Docket Item # 2
BAR CASE # 2009-0139

BAR Meeting
July 22, 2009

ISSUE: Alterations
APPLICANT: GJJV Partnership by Jeff Cain
LOCATION: 317 N West St
ZONE: RB/Residential

Figure 5. Drawing of proposed porch illustrating railing materials.

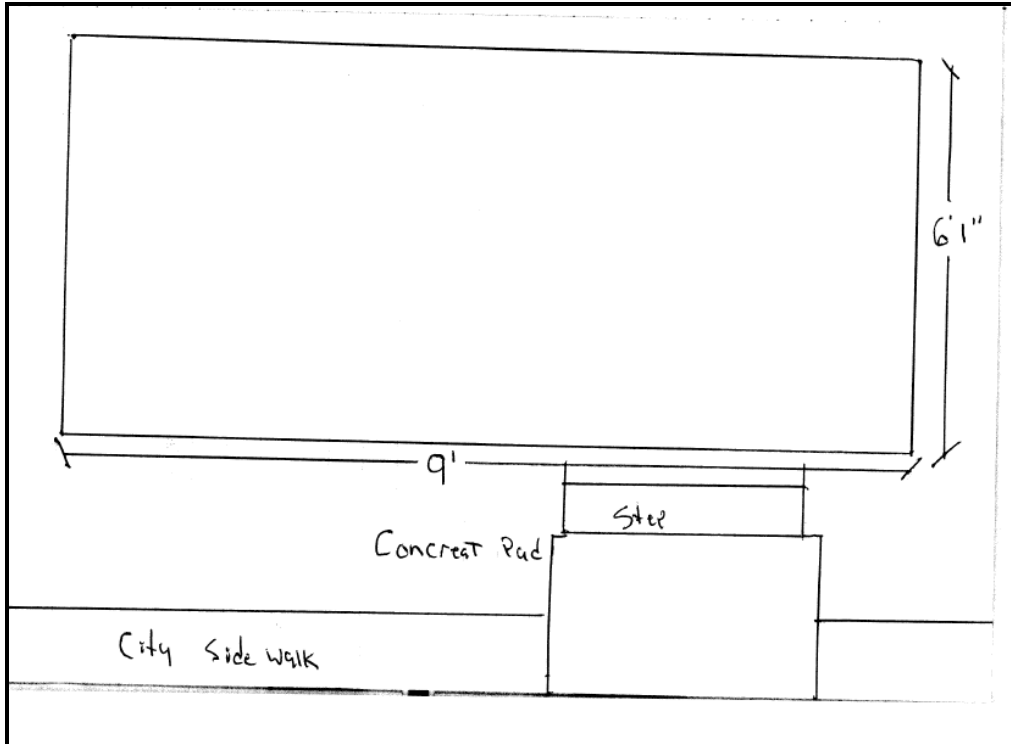
STAFF RECOMMENDATION: Staff recommends approval of the application with the condition that the top rail of the banister be a milled wood hand rail rather than a machine cut two by four.

According to the Design Guidelines, porches are an important architectural element and should be appropriate to the historic style of the structure. Considering that the porch proposed for 317 is a replacement and reconstruction of a historic element of the building, Staff feels that it would not only be appropriate but an improvement upon the existing building to reconstruct the front porch with historically appropriate materials. In addition, due to the fact that the four similar homes along the three hundred block of North West Street have retained almost identical porches, Staff feels that all materials proposed are accurate replacements. Therefore, Staff recommends approval of the application with the condition that the top rail of the banister be a milled wood hand rail rather than a machine cut two by four.
